SITE PLAN REVIEW AND APPEARANCE BOARD STAFF REPORT

Drutau Retail

Meeting	File No.	Application Type
June 26, 2024	2021-002-SPF-SPR-CLV	Level 2 Site Plan (previously Class V)
Property Owner	Applicant	Agent
M&C Capital, LLC	M&C Capital, LLC	Jordy Sopourn, RJS Architects

Consideration of a Level 2 Site Plan, Landscape Plan, and Architectural Elevations for the construction of a 1,360 square foot, one-story retail building with associated site improvements, located at 2 NW 18th Avenue.

Rendering from August 23, 2023 SPRAB meeting

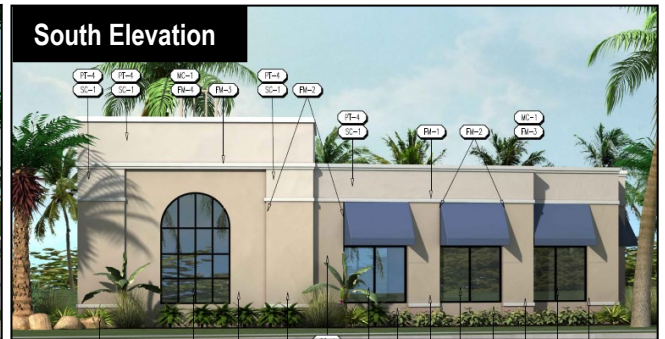
The images below show the original proposed rendering that was considered at the August 23, 2023 SPRAB meeting and the updated elevation with the amended color scheme, addition of awnings, and change of window type. On August 23, 2023, the Board voted 6-0 to continue the item with direction, expressing a desire to see more architectural detailing, a more welcoming color palette, additional window treatment on the north façade to further pronounce the front entrance, and additional treatment to the elevations to create a better-defined storefront. A comparison for each elevation is provided in the architectural analysis of the report.

Below are the original elevations proposed at the August 23, 2023 SPRAB meeting. The new proposed elevations are provided on the right.

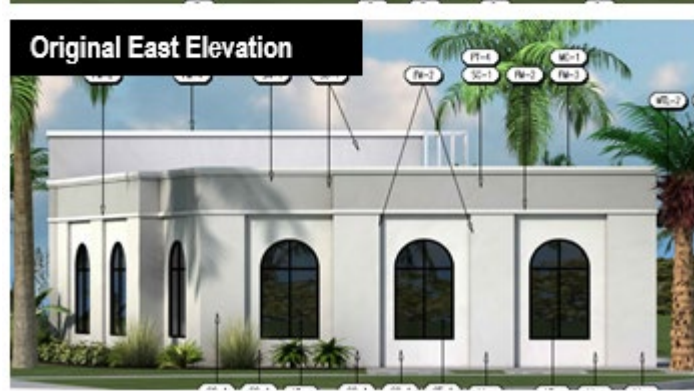
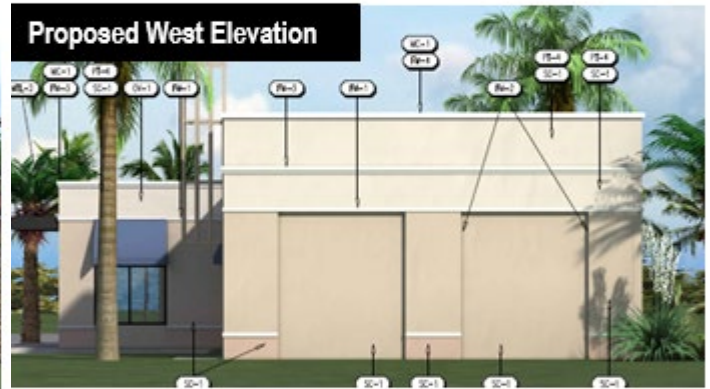
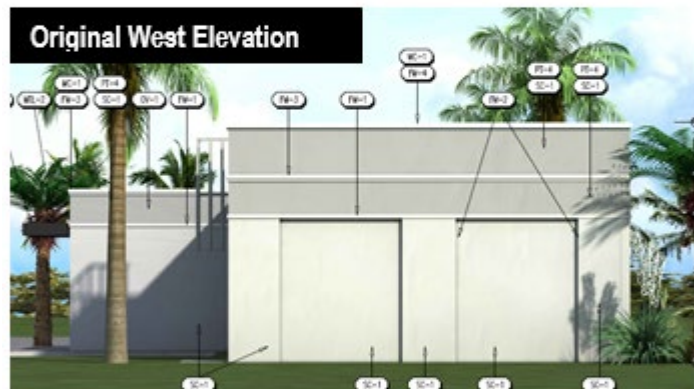
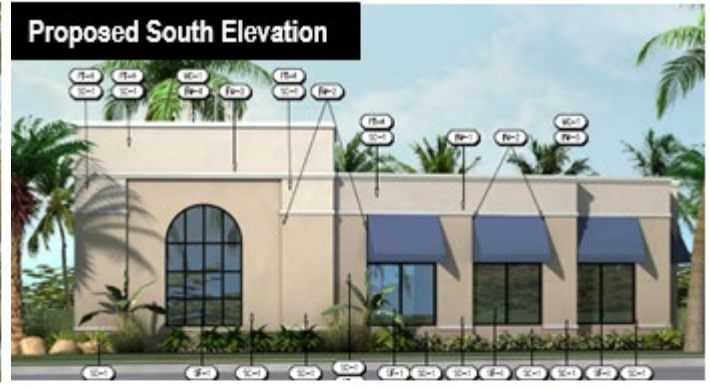
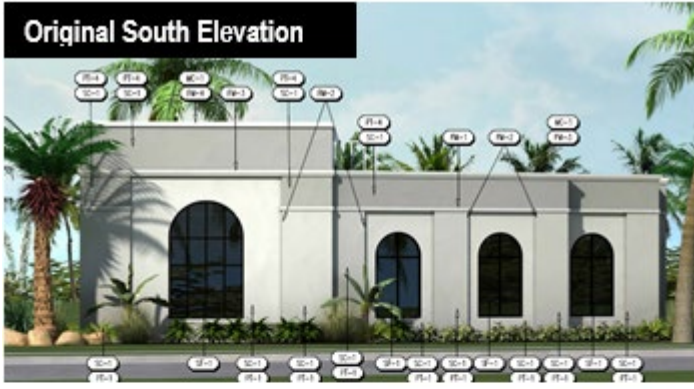
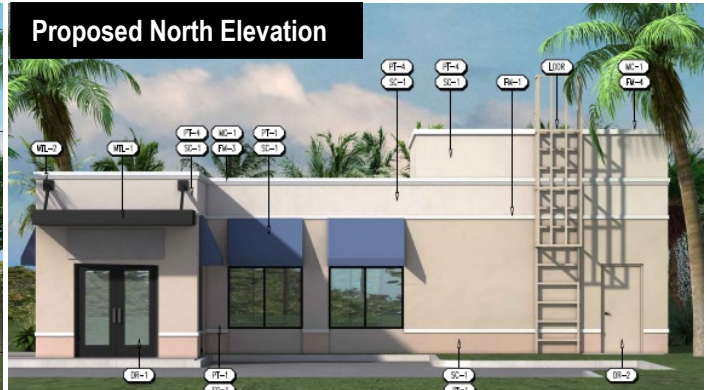
On August 23, 2023, the Board voted 6-0 to continue the item with direction, expressing a desire to see more architectural detailing, a more welcoming color palette, additional window treatment on the north façade to further pronounce the front entrance, and additional treatment to the elevations to create a better-defined storefront. To address the Board’s concerns, the applicant has revised the building’s color palette from a variation of greys to warmer toned beiges, installed blue awnings on the north, south, and east facades, changed most of the half-domed windows to rectangular windows, included additional molding detail at the base of the building, and added window treatments to the north façade.

The Board should consider whether the proposed changes address the Board’s comments from the August 23, 2023, SPRAB meeting, and if the changes help create a defined front entrance and storefront and introduce a color palette that is harmonious with the surrounding development.

The building possesses elements from both the Classical Traditional and Masonry Modern architectural style. A large half-oval window is located on the south façade facing West Atlantic Avenue. Windows have been added to the north façade, which serves as the main entrance point and faces the six-car parking lot. The structure is generally harmonious with the surrounding one-story commercial and light industrial development. Based on the revisions made by the applicant in response to the Board’s comments, consideration should be given as to whether the changes implement proper design elements to reflect the intended retail use and define the main entrance to the building.
